RODEIO BONITO SMALL HYDRO POWER PROJECT IN BRAZIL

REPORT NO. 2008-1120

VALIDATION REPORT

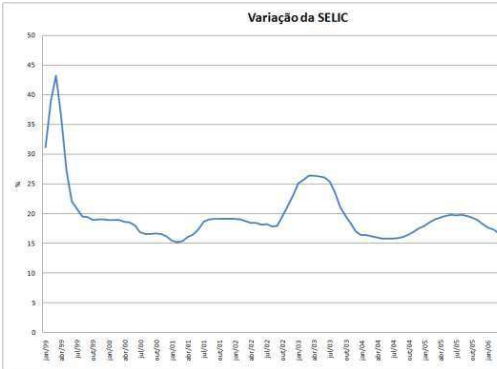
Draft report clarifications and corrective action requests by validation team	Ref. to checklist question in table 2	Summary of project owner response	Validation team conclusion
		<p>borrowed. Project participant was created in 2005 and had no such guarantees. In other words, project participant will have to use its own balance sheet and capital to raise funds from BNDES. In case project underperform or become unfeasible, BNDES would call project participant's guarantees and real assets up to their initial credit exposure. In addition to leveraging their balance sheet with sizeable borrowings, project participant would face completion risk of the project. Completion risk is mitigated by guarantees pledged by the construction company; which are however, of limited recourse. These necessary guarantees, costs and risks associated were considered very excessive by the project participant and understood as a barrier.</p> <p>As required for ii), the project participant provided an investment analysis of Rodeio Bonito project. Shareholders IRR will be used as project financial indicator and as reference to represent the standard returns in the market the Brazilian interest rate will</p>

Draft report clarifications and corrective action requests by validation team	Ref. to checklist question in table 2	Summary of project owner response	Validation team conclusion
		<p>be used, known as <i>SELIC</i> (Special System of Clearance sale and of Custody).</p> <p><i>SELIC</i> is a great computerized system, under the responsibility of the Central Bank of Brazil and of the National Association of the Institutions of the Open Markets, since 1980, when it was created.</p> <p>The Committee of National Monetary Politics (COPOM) stipulates <i>SELIC</i> Target that can be defined as the average rate of the daily financings, with ballast in federal titles, select in the <i>Selic</i> System, which is in force for the whole period among ordinary meetings of the Committee.</p> <p>The <i>SELIC</i> rate is cleaned in the <i>SELIC</i> System and obtained by the calculation of the considered and adjusted medium tax of the financing operations by one day, ballasted in federal public titles and studied in referred him system or in clearing house and clearance sale of assets. The operators of the institutions transfer <i>SELIC</i>, on line, the relative businesses to public titles</p>

Draft report clarifications and corrective action requests by validation team	Ref. to checklist question in table 2	Summary of project owner response	Validation team conclusion
		<p>involving banks that buy and that you/they sell those titles. Therefore, the Selic rate is the rate that remunerates the investors in the purchase business and sale of public titles.</p> <p>The qualified financial institutions, such as banks, savings banks, society's brokers of titles and values furniture, distributing societies of titles are capable to make this kind of operation.</p> <p>The most liquid government bond is the LFT (floating rate bonds based on the daily reference rate of the Central Bank of Brazil). As of January 2006, 37% of the domestic federal debt was in LFTs and had duration of one day (Source: Tesouro Nacional; www.tesouro.fazenda.gov.br). This bond rate almost follows the CDI rate, which is influenced by the SELIC rate, defined by COPOM.</p> <p>The SELIC rate has been oscillating since 1999, from a minimum of 11.73% a.a. in July 2007 up to a maximum of 43.25% a.a. in January 2003</p>

Draft report clarifications and corrective action requests by validation team	Ref. to checklist question in table 2	Summary of project owner response	Validation team conclusion
		<p>(see here below) .</p>  <p>(Source: Banco Central do Brasil)</p> <p>In order to be conservative, it will be considered the the average value of 2 years before the investment decision. From January 2005 to December 2006, the average value for the SELIC was 17 %. The Rodeio Bonito project investment analysis</p>
